Ignition Module Overheat Condition

Models Affected;

Following 1999 model year engines within the listed serial number range, equipped with Thunderbolt-V ignition module (as shown).
500 Carb (OL414644 to OL415001), 500 Bulldog (OL414620 to OL414986)
525SC (OL414720 to OL414967), 800SC (OL414638 to OL414745)

a - Thunderbolt V Module - Two Separate Connectors

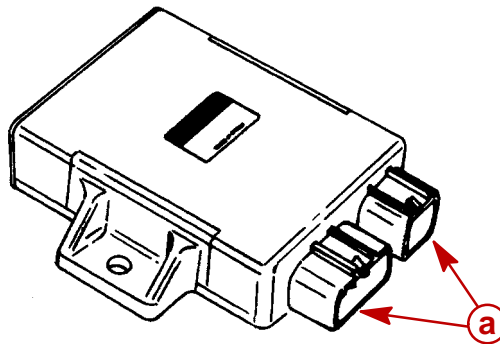
Excessive internal ignition module heat may result in module failure.

Installation of an IGNITION MODULE HEAT SINK PLATE KIT 841868A1 which fits against the ignition module to help draw excessive heat away from the module.
